UNC Charlotte Phase 16

Addendum #4

Revision Narrative

2021-09-08

E-202S

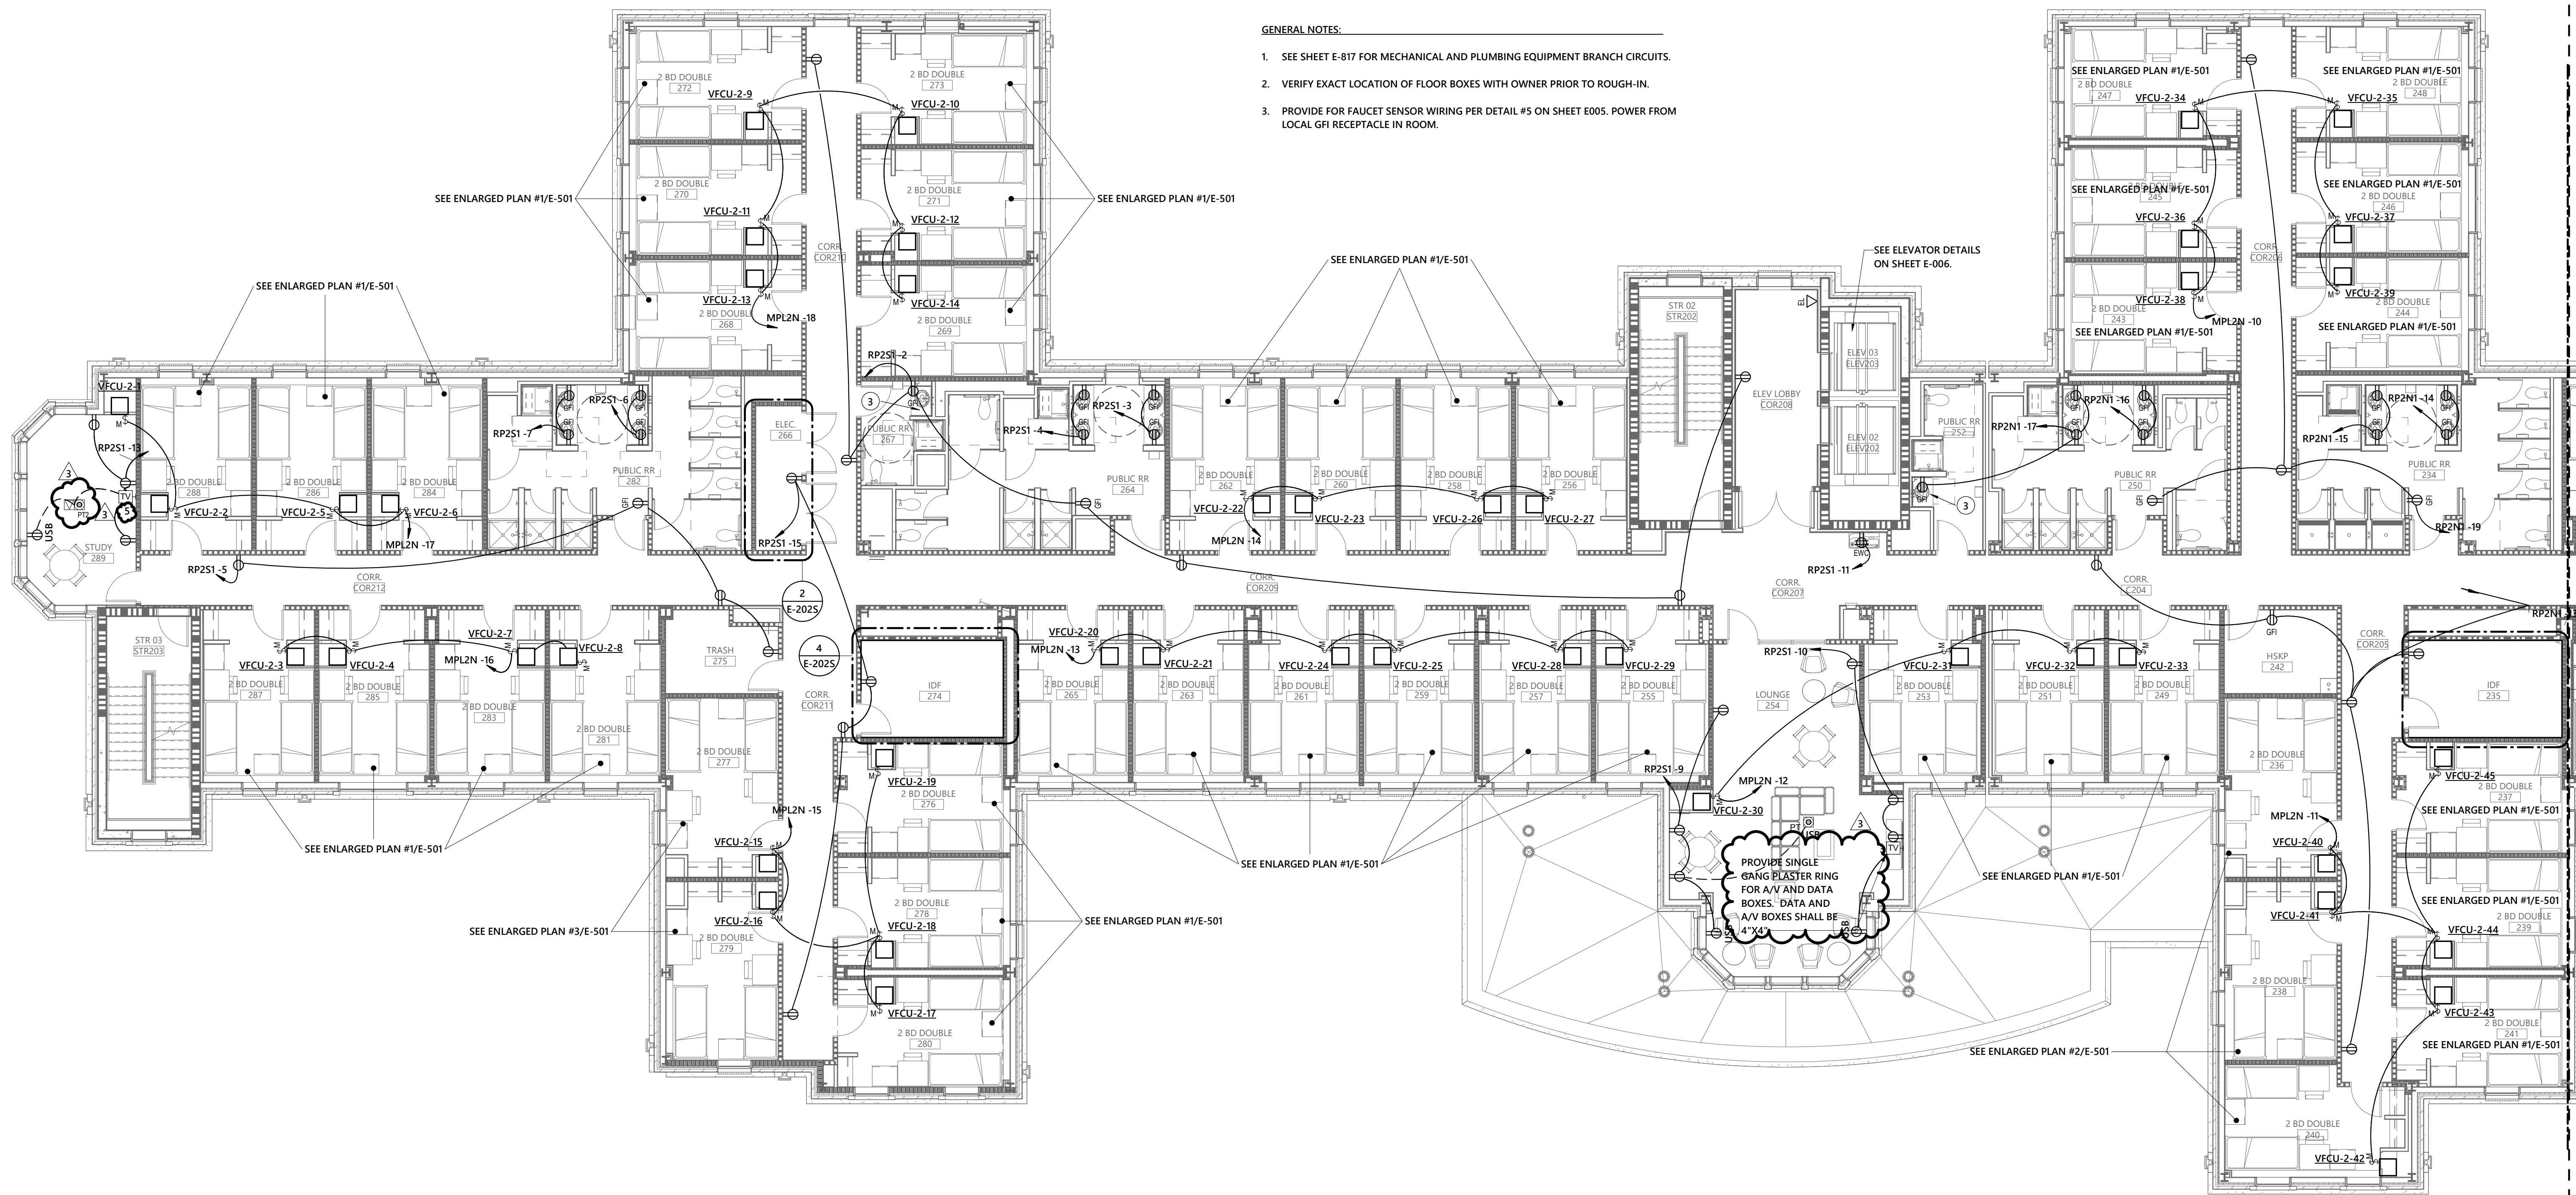
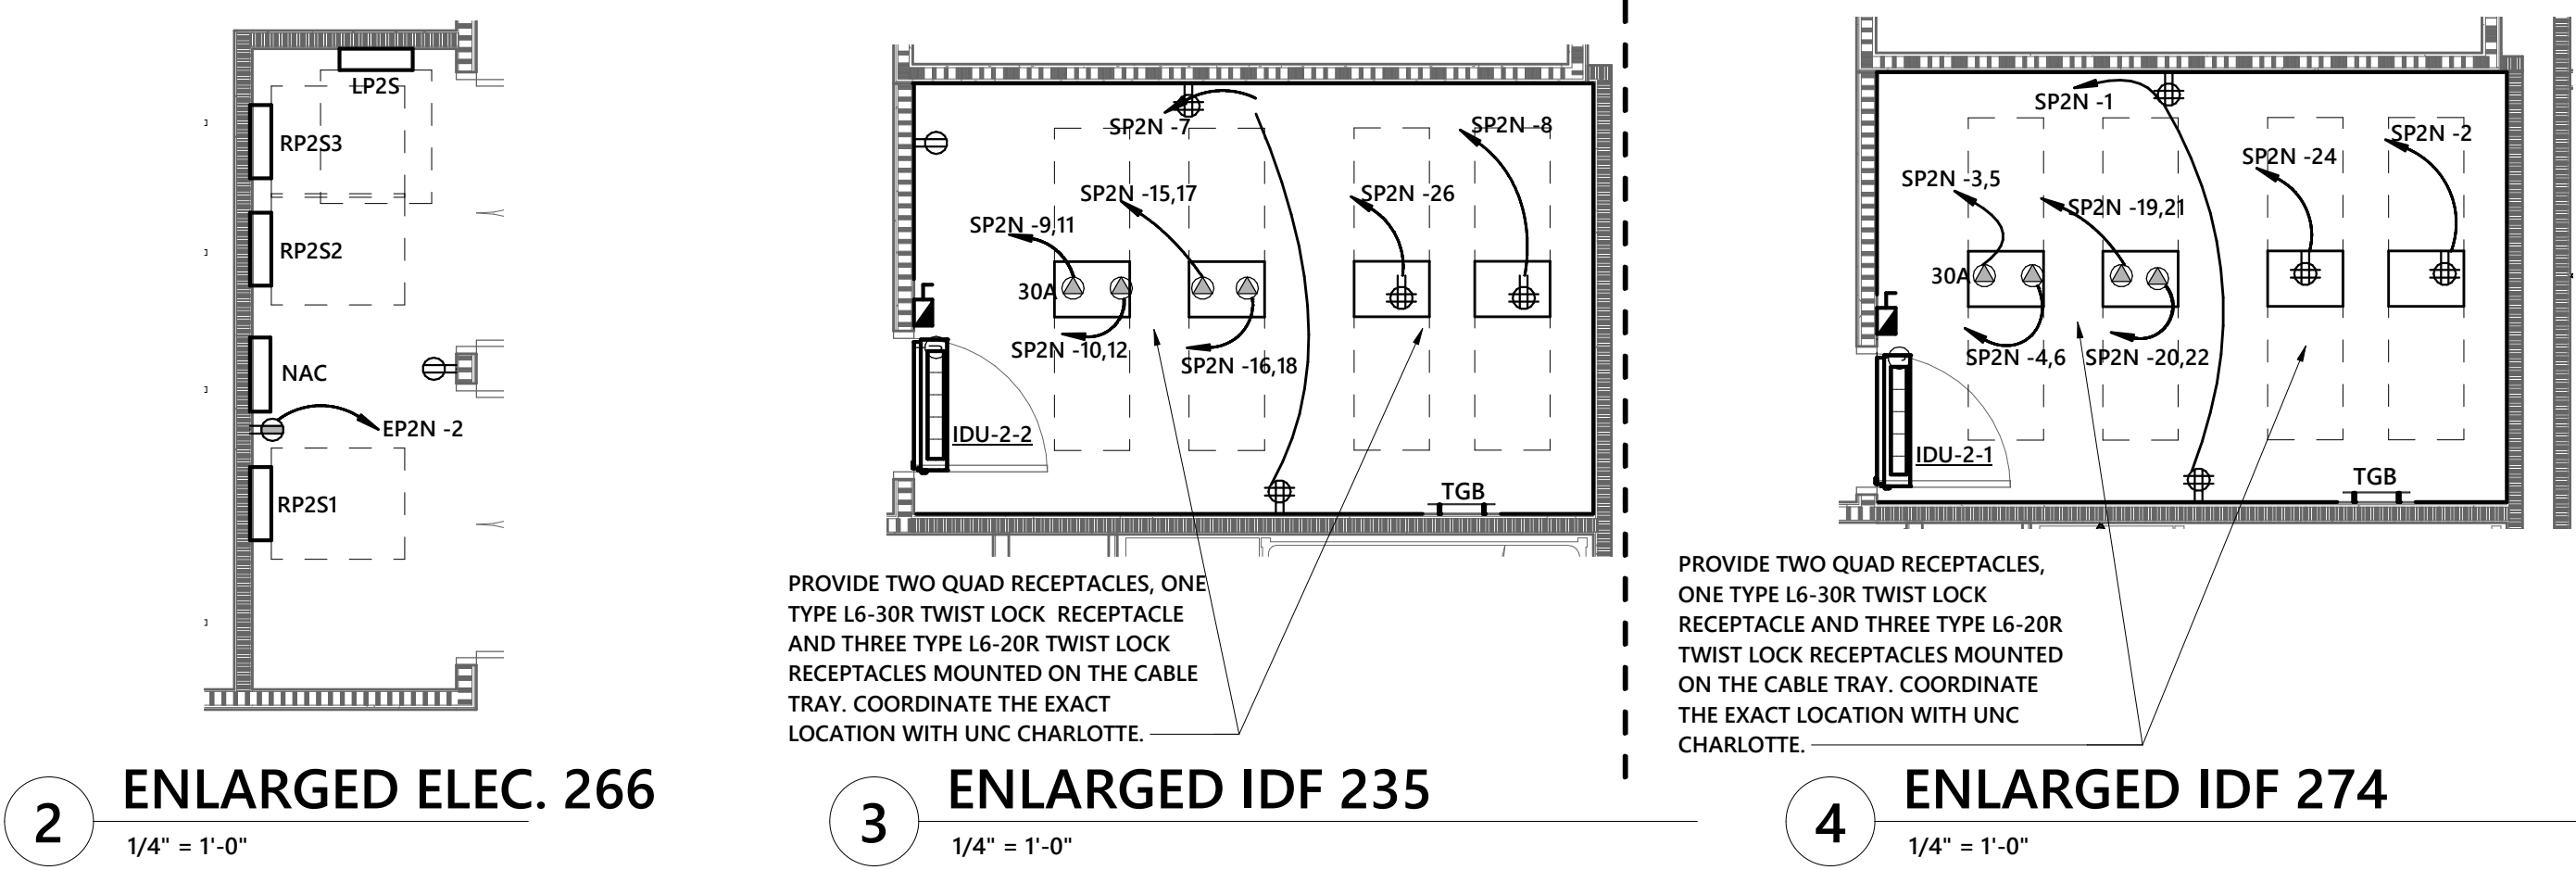
E-202S - Changed TV type. Added note for opening type of junction box. Poke thru type changed.

E-203N
 Optima # 18-0001 Sheet 21 of 84
 BM 360//18NCC016 RH PHASE XVI/18-0001_UNCC-XVI A-MEP-V20.rvt

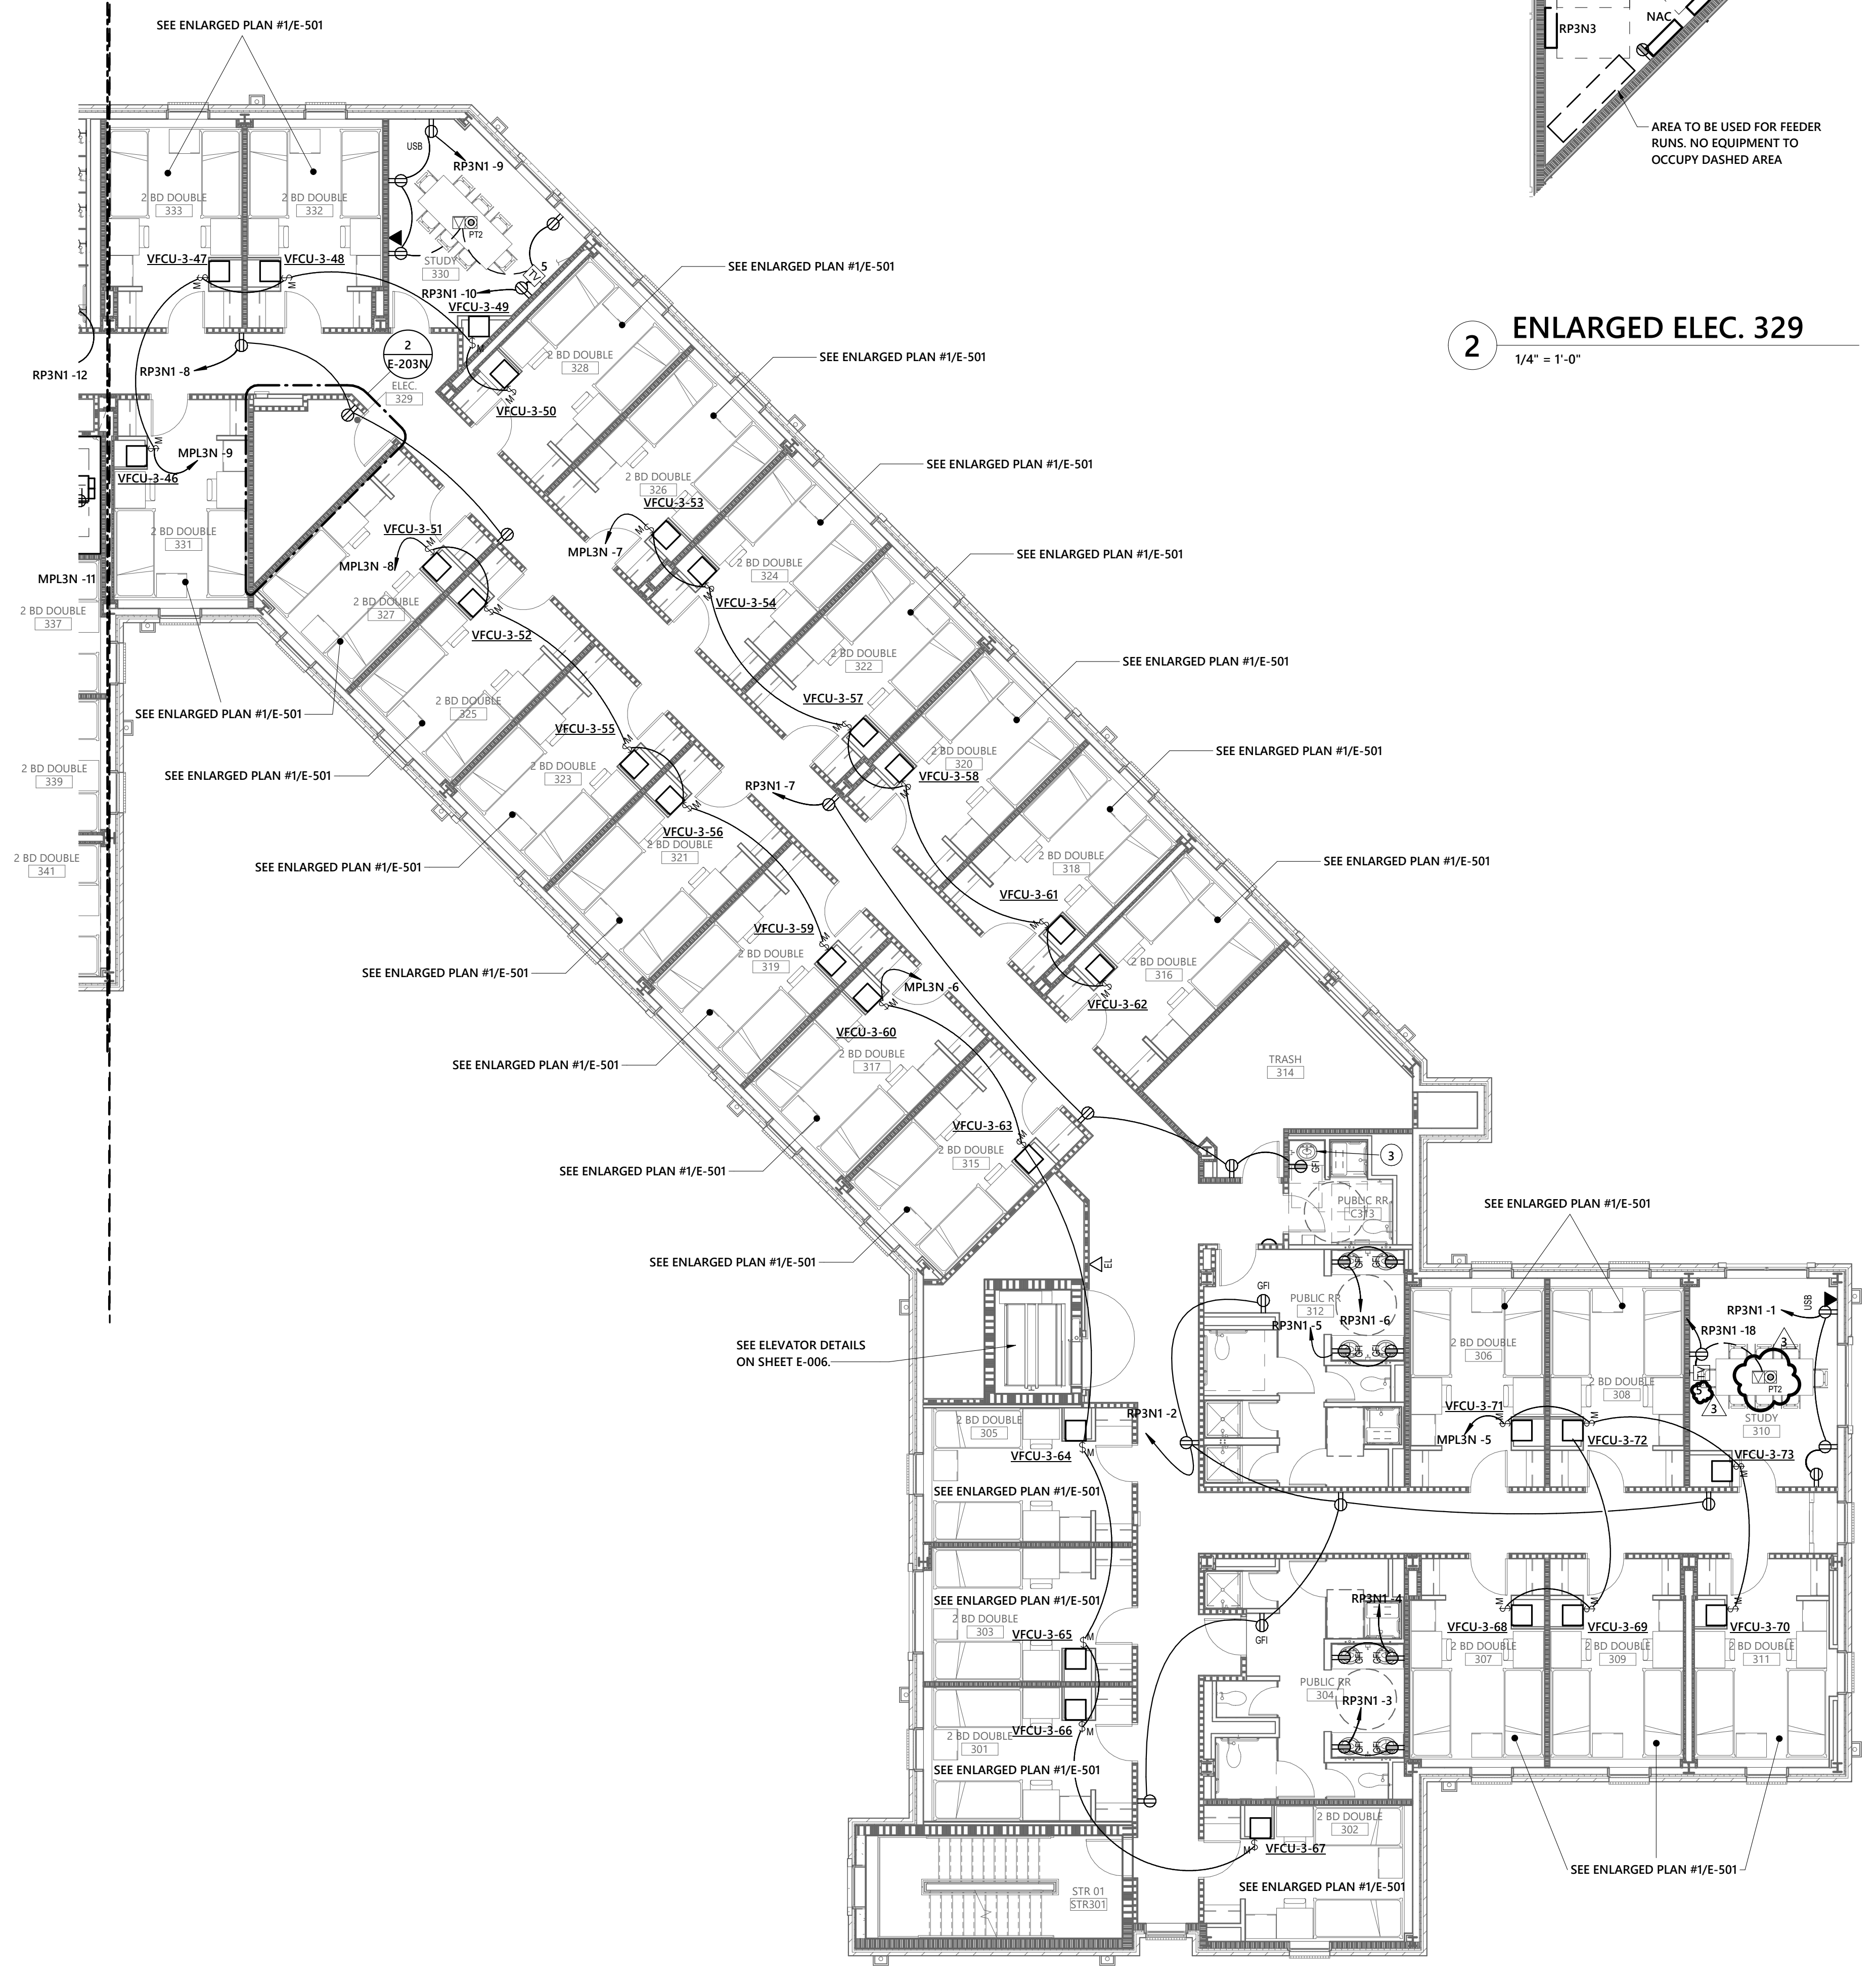
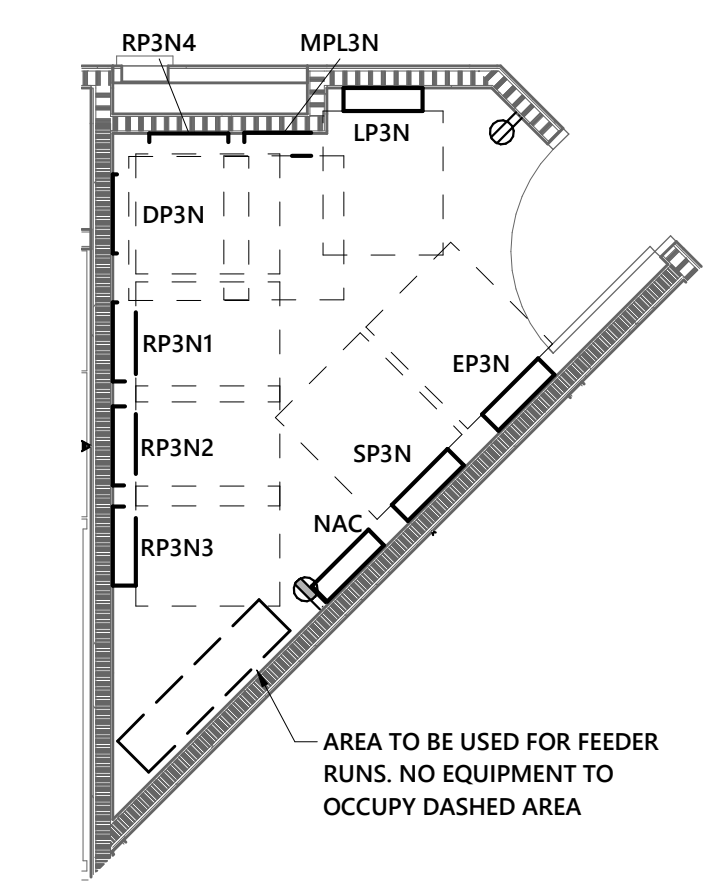
E-203N - Changed TV type. Poke thru type changed.
